Town of Orangetown Planning Board Planning Board Meeting: March 25, 2020

Project: 27 Greenbush Road Site Plan: Continued item from October 7, 2019 meeting, PB #19-64

Narrative Summary
Prepare for:
27 Greenbush Road Site Plan
(74.11-1-12)

27 Greenbush Road Site Plan

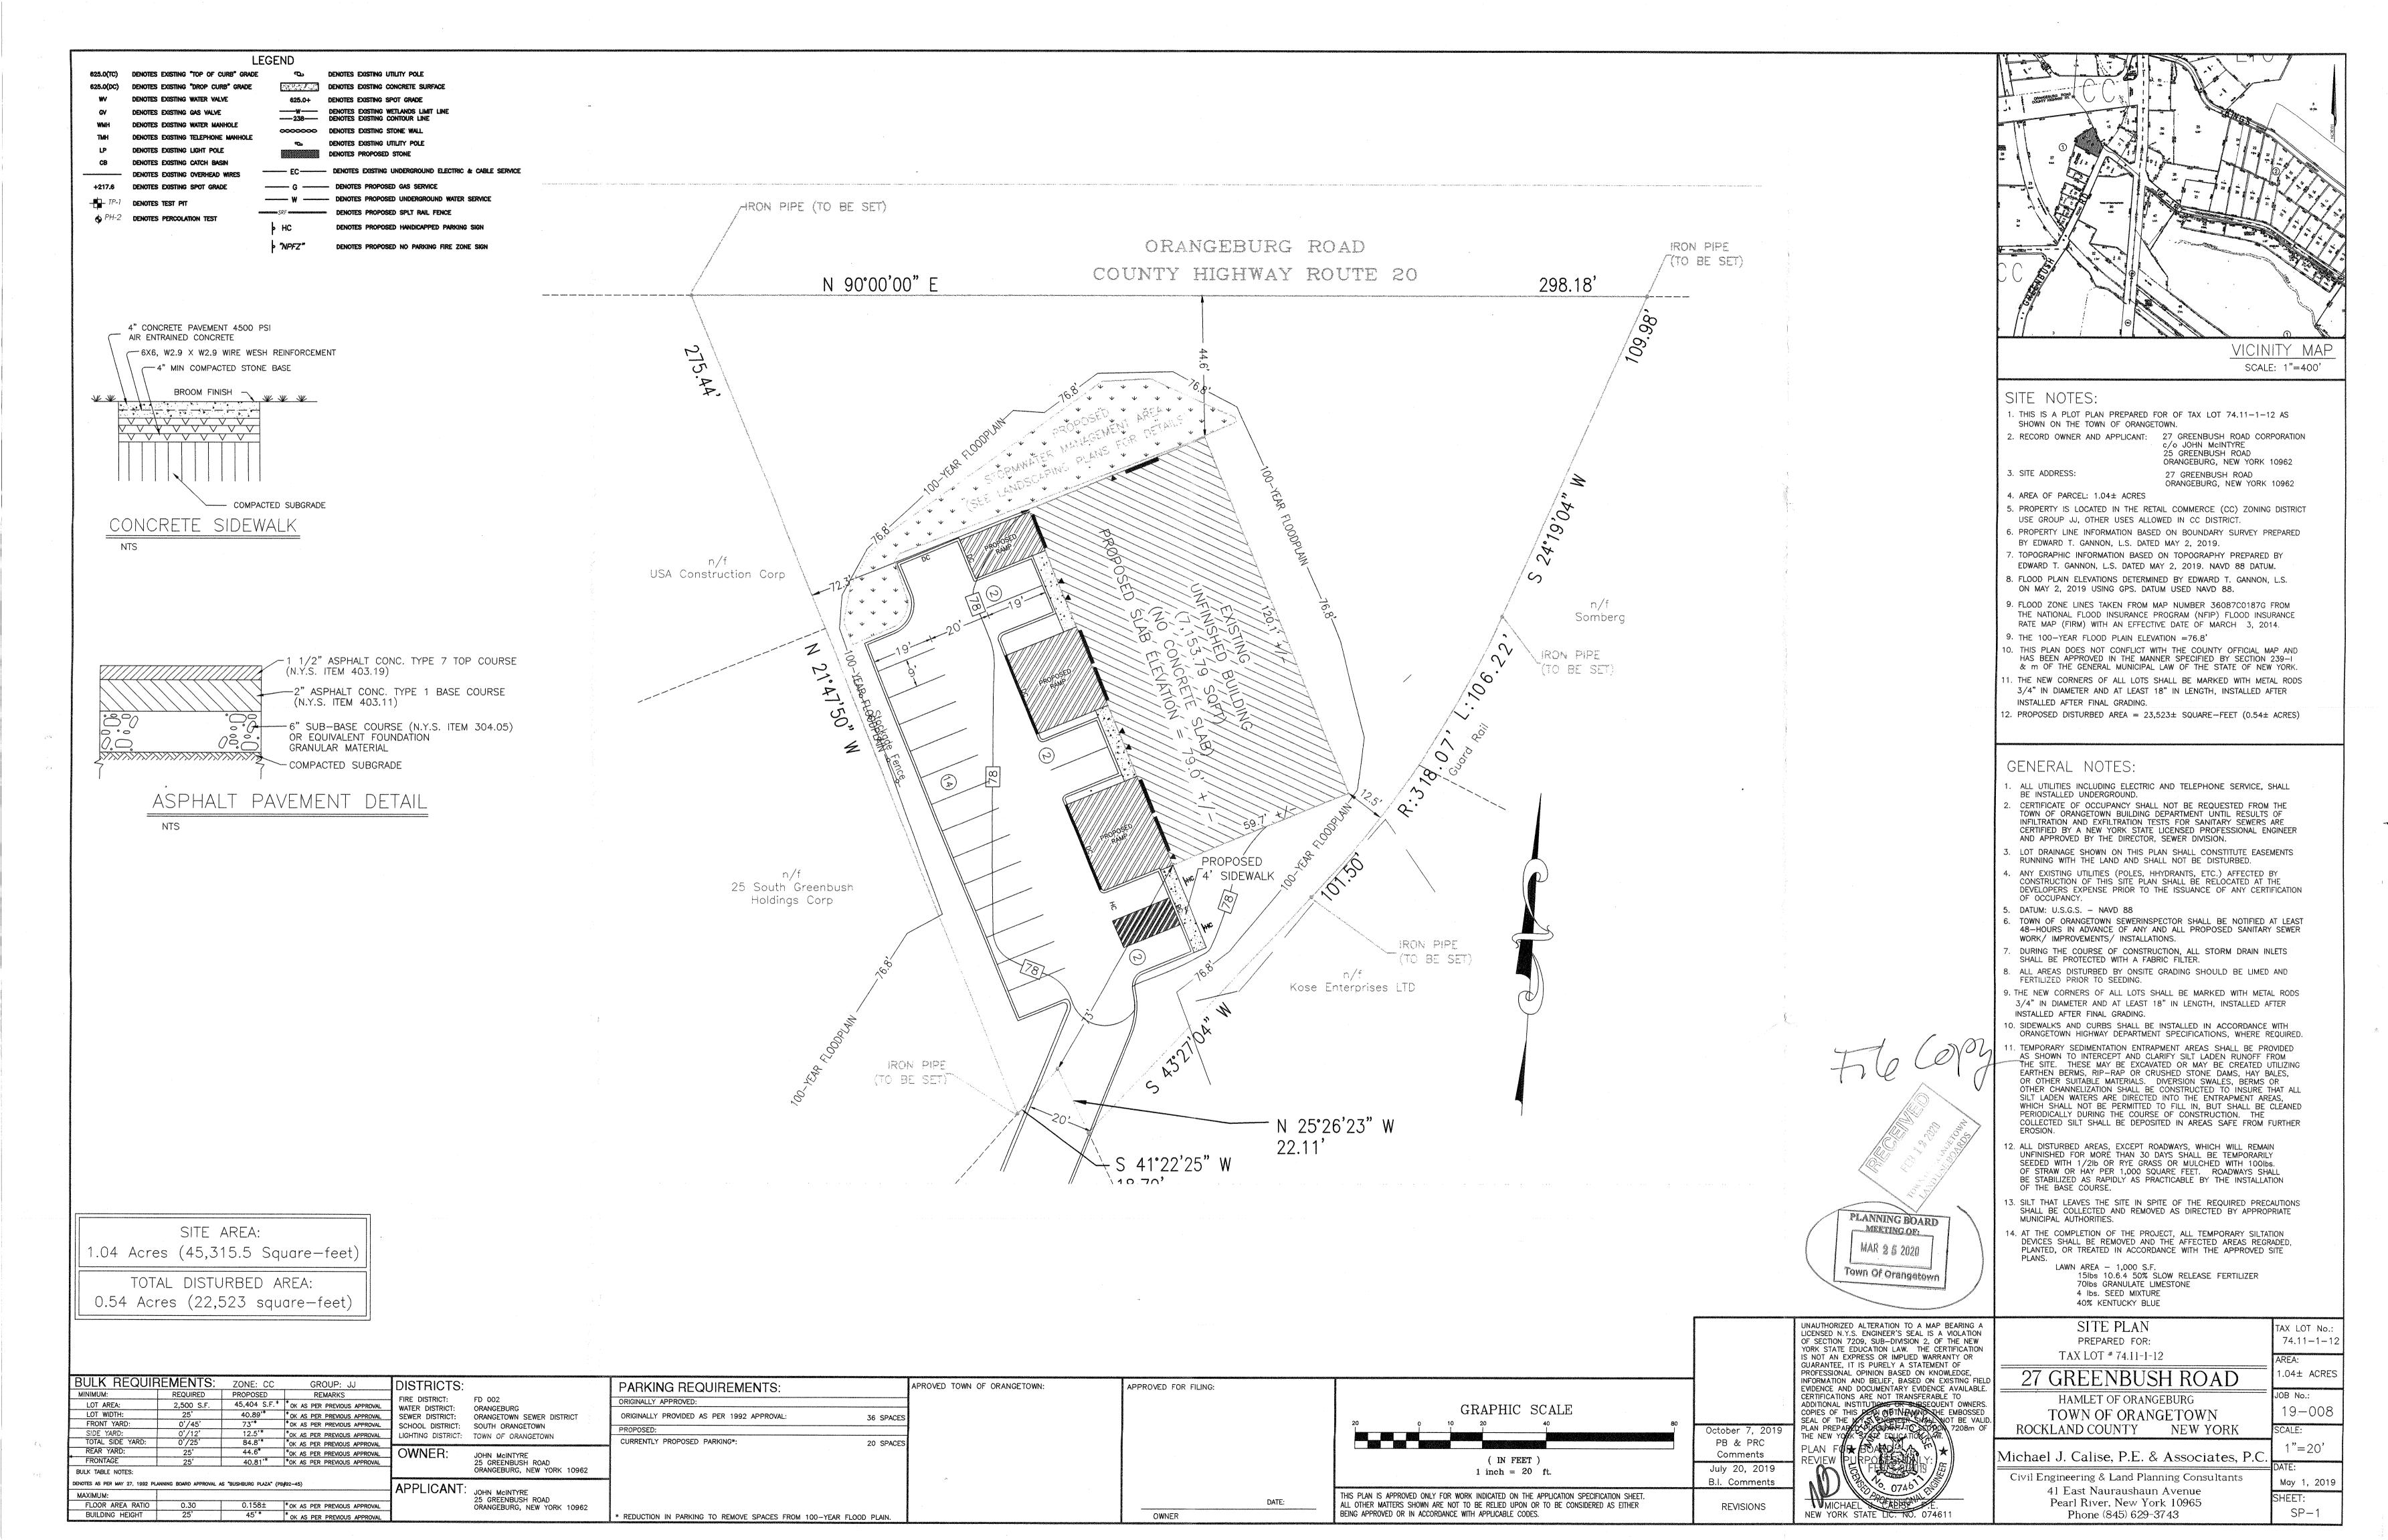
C. Brooker Engineering letter dated October 5, 2019 comments are addressed as follows:

- 1. Comments noted, topography was field checked, reviewed and plans revised.
- 2. Survey datum shown, as requested. A note has been added to the plan to express the datum information.

- 3. Comment noted, an elevation certificate will be prepared once construction is completed.
- 4. Comment noted, the Rockland County Drainage Agency and all required permits will be obtained.

- 5. Comment noted, the proposed contours have been added as requested.
- 6. Comment noted, catch basins expressed on the plans were based on the originally approved site plan.

- 7. The finished floor elevation was noted on the original plan at elevation <79.0'>. the freeboard is <2.2'>.
- 8. Comment noted no disturbances are planned outside the defined limit of disturbance (L.O.D.) expressed on the plans.

- 9. The standalone field inlet shown on the plans has been and is currently inaccessible. Further investigation is being scheduled with the owner.
- 10. The soil stockpiles have been removed by the Owner.

- 11. Comment noted, note added to plan as requested.
- 12. Comment noted, information requested will be presented in drainage report via separate cover.

- 13. Comment noted, drainage report will be submitted via separate cover.
- 14. Comment noted, soil erosion control plan presented for review.

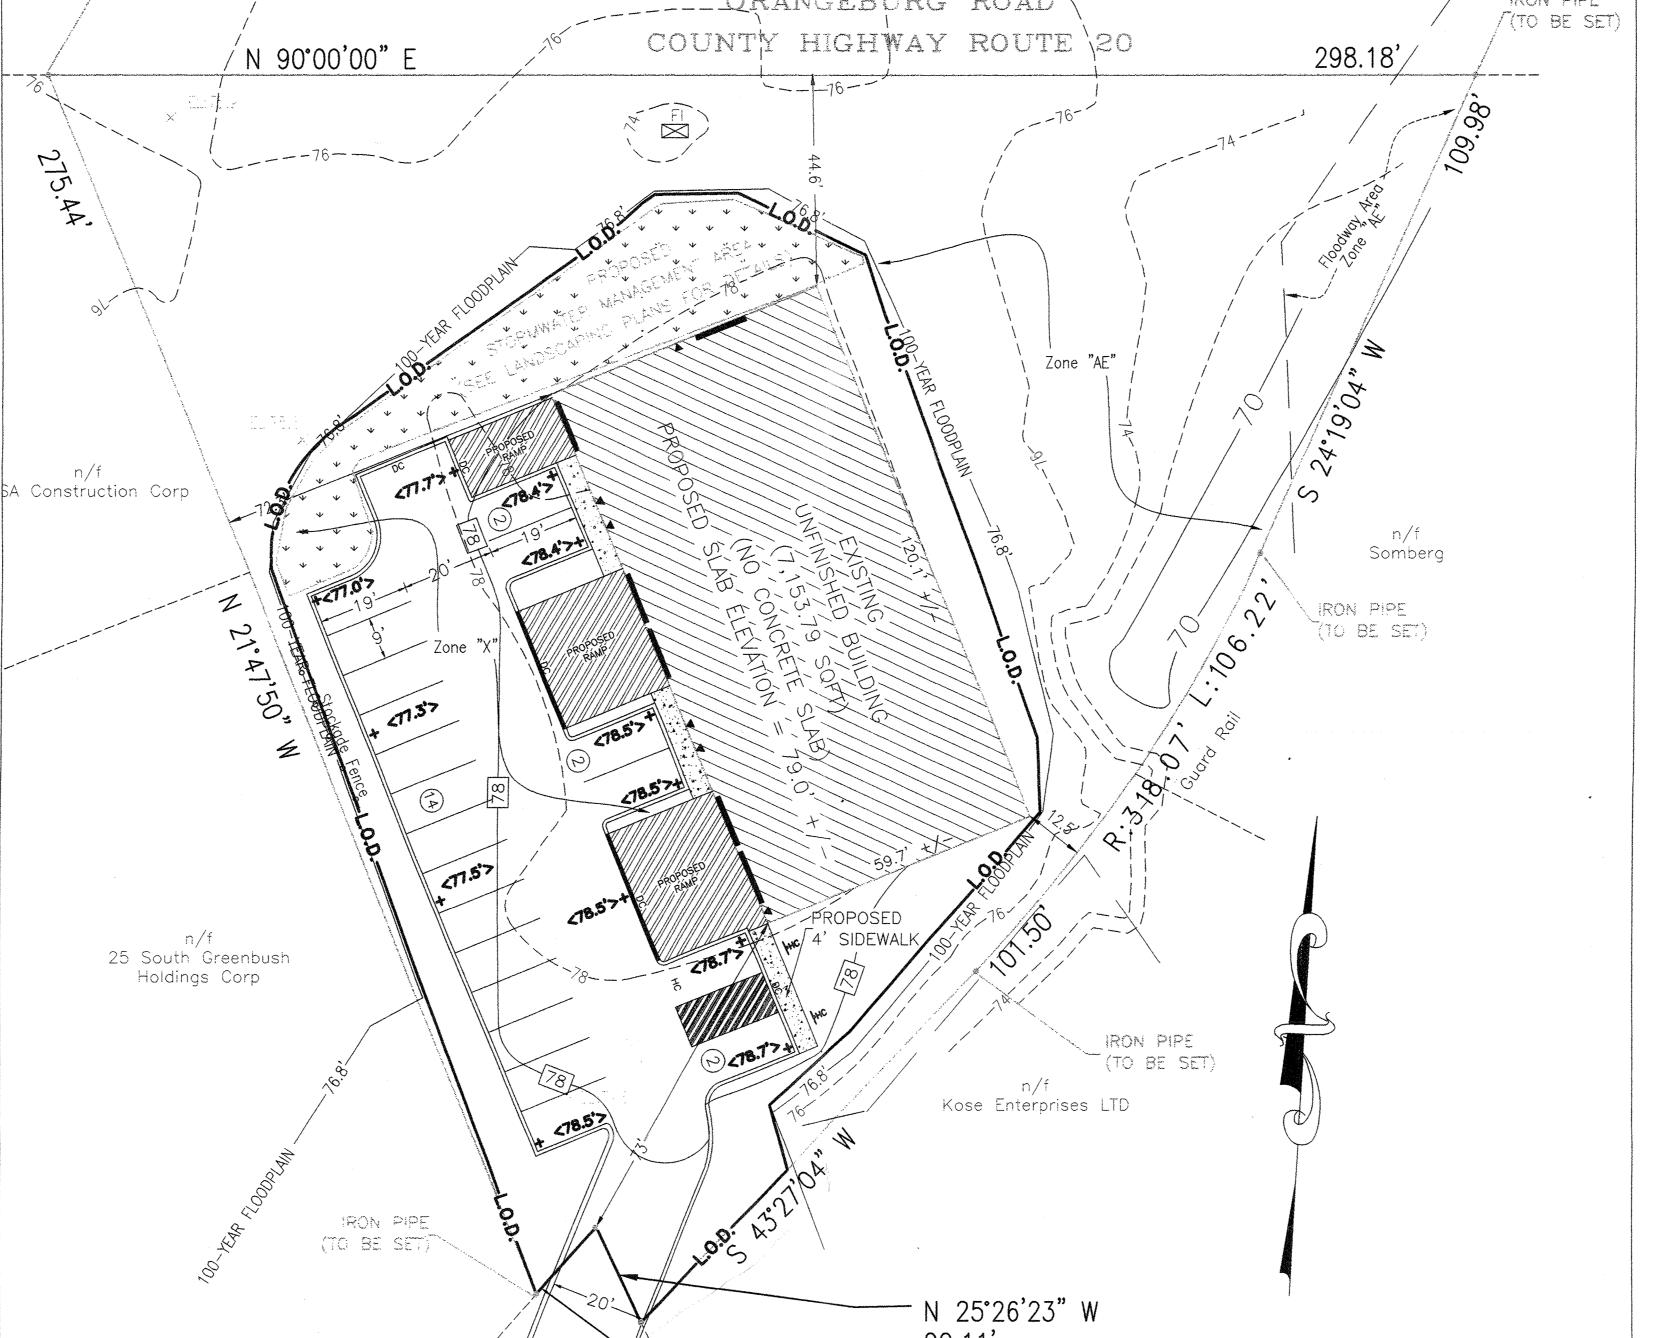
- 10. Soil erosion and sediment control plans and details shall be added to the drawings.
- 11. There is a seemingly standalone field inlet shown along the northern side of the lot, what is its purpose? What is it connected to? Is it to remain?

- 9. The outlet of the existing field inlet west of the building should be shown.
- 10. Soil stockpiles west of the building were present on the site north at the time of our site visit. These should be included on the Site Plan and the proposed ground cover in this area should be noted.
- 11. Total land disturbance should be provided. The limit of disturbance line should be added to the plan.
- 12. Existing and proposed impervious surfaces should be quantified and stormwater mitigation measures should be provided.
- 13. A Sediment and Erosion Control Plan should be prepared.

- 10. Comment noted, a Soil Erosion Control plan has been included in this submission for review
- 11. The existing standalone field inlet shown on the plans has been and is currently inaccessible, further investigation is being scheduled with the owner.
